VISIT TO THE BASALT WASTE
ISOLATION PROJECT (BWIP)
HANFORD, WASHINGTON

DIVISION OF WASTE MANAGEMENT
U.S. NUCLEAR REGULATORY COMMISSION

NOVEMBER 1981

Figure 1

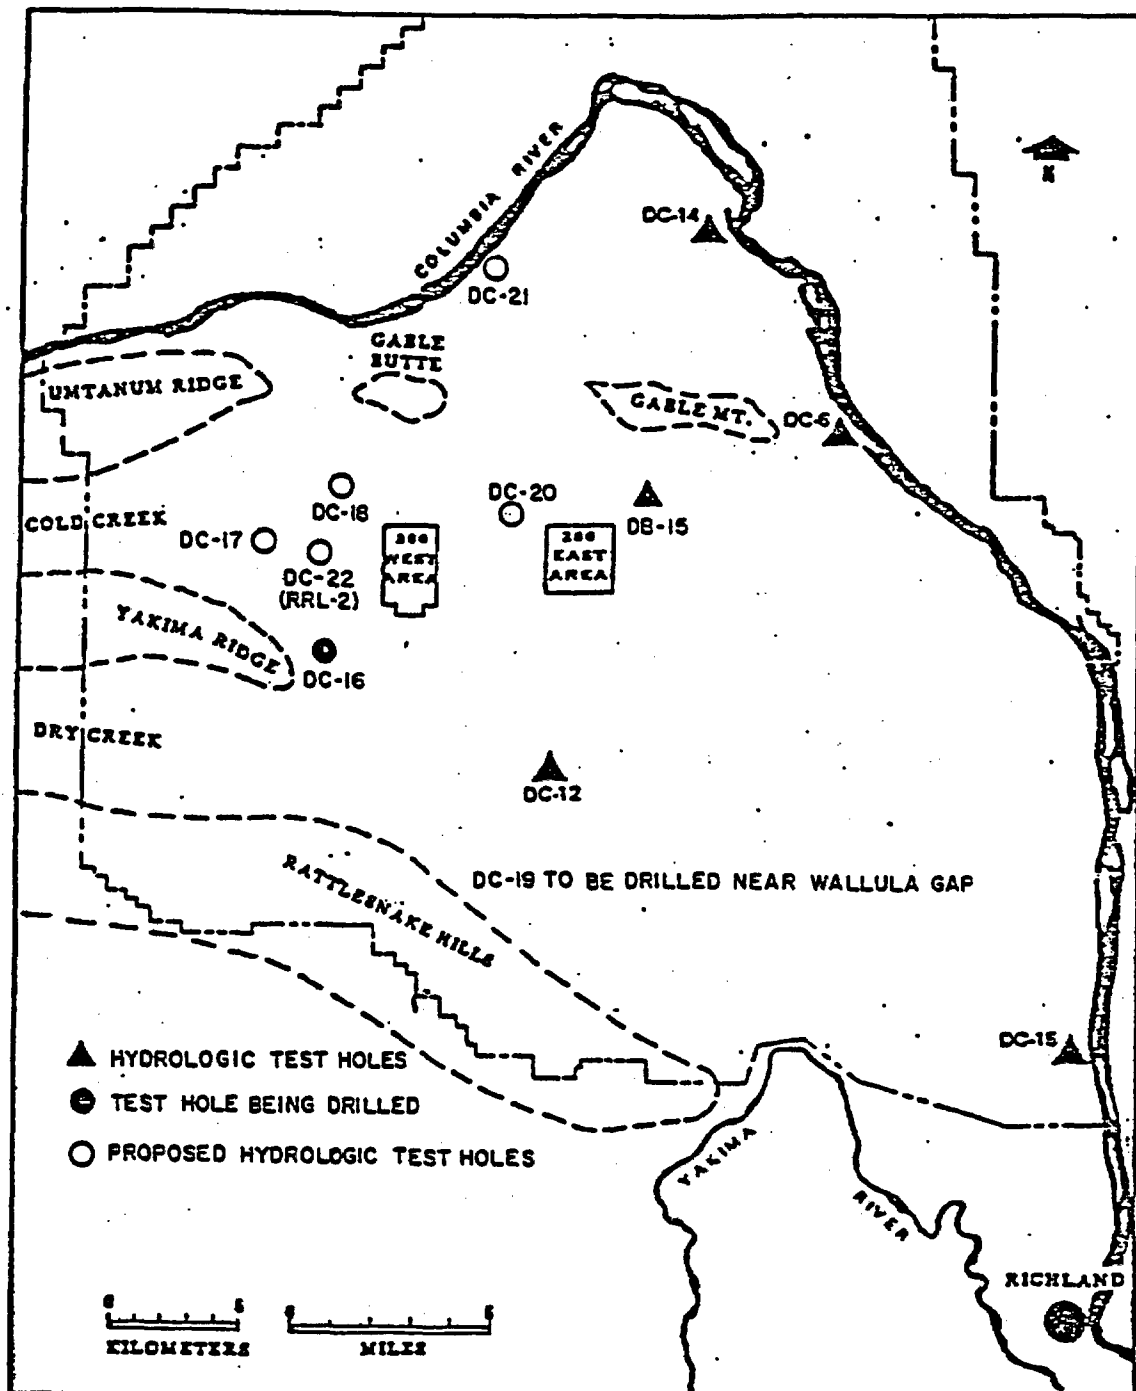
Plans for the next five years call for the drilling and testing of six small diameter core holes (Figure 1). Paired hole testing of the Umtanum by low volume pumping is planned in DC-4 and DC-5 and/or DC-7 and DC-8. The distances between these pairs of holes is less than 150 feet, and the holes are more than 5 miles from the RRL. While the data from the planned paired hole testing will be helpful, the value will be limited for several reasons. (1) Because of the close spacing of hole pairs (less than 150 feet) only a limited volume of rock will be tested. (2) Casing presently in the holes restricts testing to the Grande Ronde; no properties of higher units will be measured. (3) In view of the distance between the holes and the RRL, and the expectable lateral variation within the Umtanum, it is questionable whether the test values for the Umtanum can be applied to the RRL.

The NRC is concerned that the hydrologic site characterization program, as planned, will not produce reliable vertical permeability and storativity data. (Appendix B, pages 5, 11, and 13; and Appendix E, pages 4 and 5). Without this information, the data base may not be adequate to support a full evaluation of site suitability and design that will be contained in a construction authorization application, if this document is advanced in the late 1980s.

(FIGURE 1)

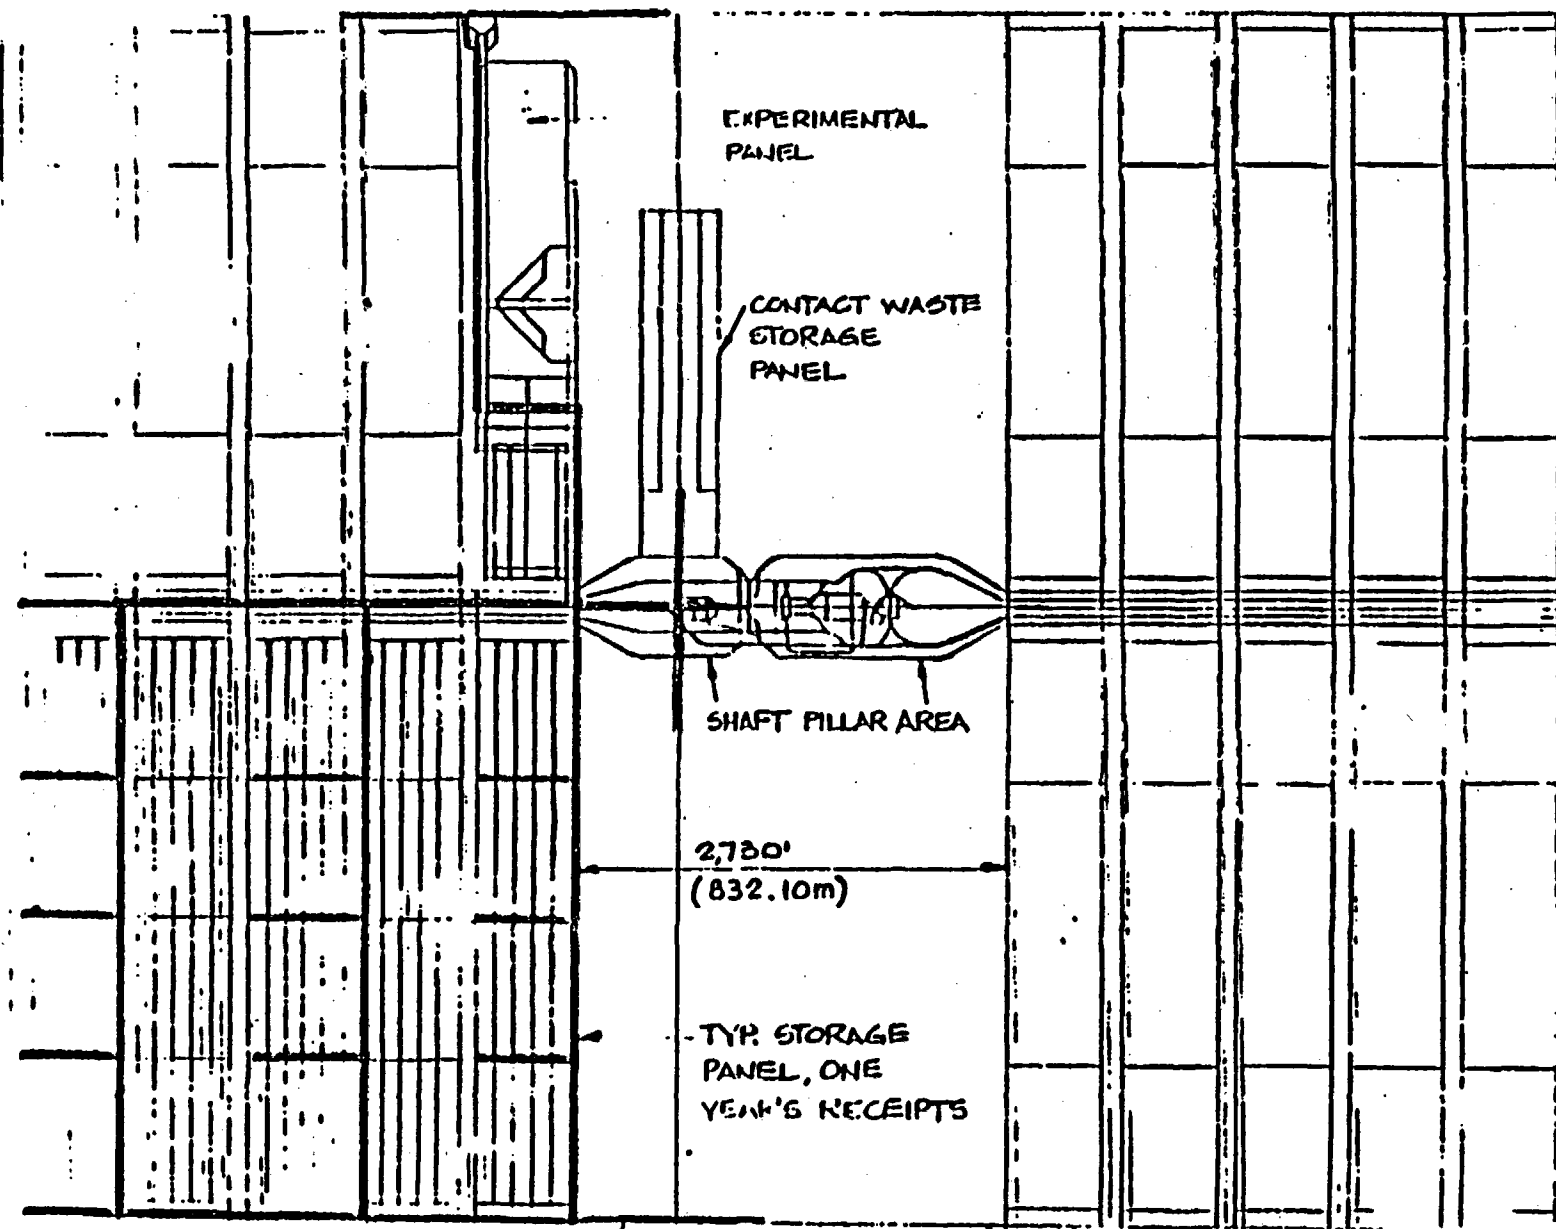
The proposed repository layout incorporates a substantial shaft pillar between two main storage areas. This pillar, 7800'x2730', will contain the five main repository shafts, the contact waste storage panel, and the ESTF (Figure 1). The exact location of the ESTF within the shaft pillar has not been specified. It is our opinion that this is the correct decision, and that the shaft pillar is sufficiently large to contain the ESTF without jeopardizing the performance of the repository. Information obtained from this initial entry into the repository horizon will provide a base with which to compare and evaluate the results of ongoing exploration drilling and development activities, which are an essential part of repository design verification.
